CITY PLANNING COMMISSION

APPLICATION: 1. Environmental Determination
2. Tentative Map

PROPOSAL: The applicant is requesting the necessary entitlements to divide 15± acres into 54 single family lots.

APPLC. NO. P83-001

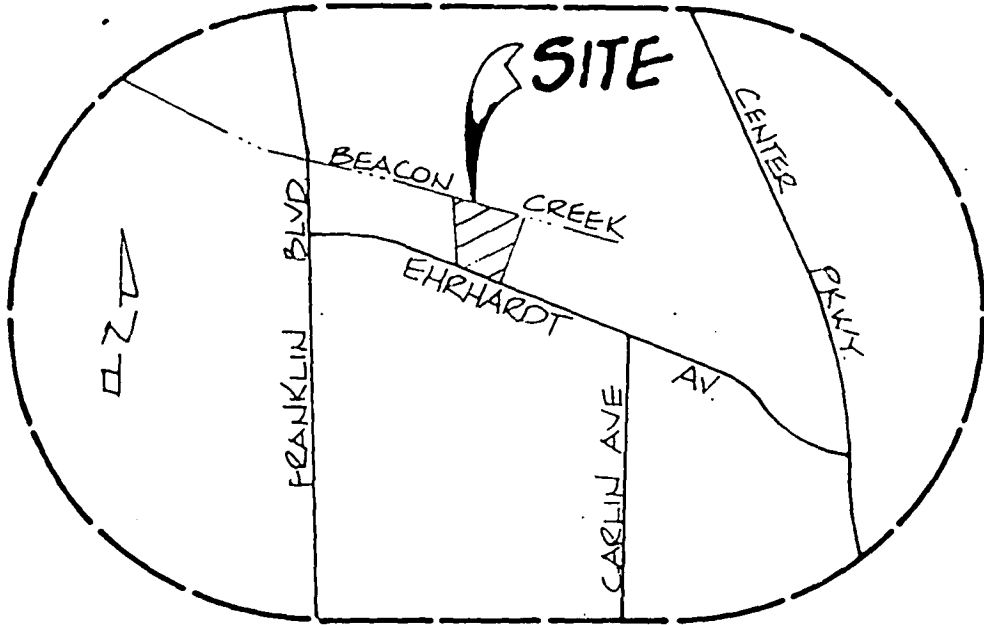
2. The map design indicates 35 percent north/south lot orientation (19 lots). An additional 34 (63%) units can be constructed with the predominant glazing located on the south wall. These lots are all wide enough so that the units will not be shadowed by their southern neighbor. This makes a total of 98 percent of the units with north/south trending side lot lines or adequate south wall glazing access. (See Exhibit A for various lots.)

4. The City Traffic Engineer has requested different names for two proposed streets. This is to eliminate conflict or confusion with existing street names in the City. Due to the overall size of the subdivision, the Traffic Engineer has requested that the entrance street from Ehrhardt Avenue be made a 50-foot right-of-way up to Euler Way. (See Exhibit A.)

- e. Dedicate Lot A to the City for future Route 148;
 - f. The entrance street shall be a 50-foot right-of-way from Ehrhardt Avenue to Euler Way;
 - g. Las Cocas shall be renamed to the satisfaction of the City Traffic Engineer;

- i. Rename Euler Way (north/south street portion fronting on Lots 60,61,104 and 105) to the satisfaction of the Traffic Engineer.
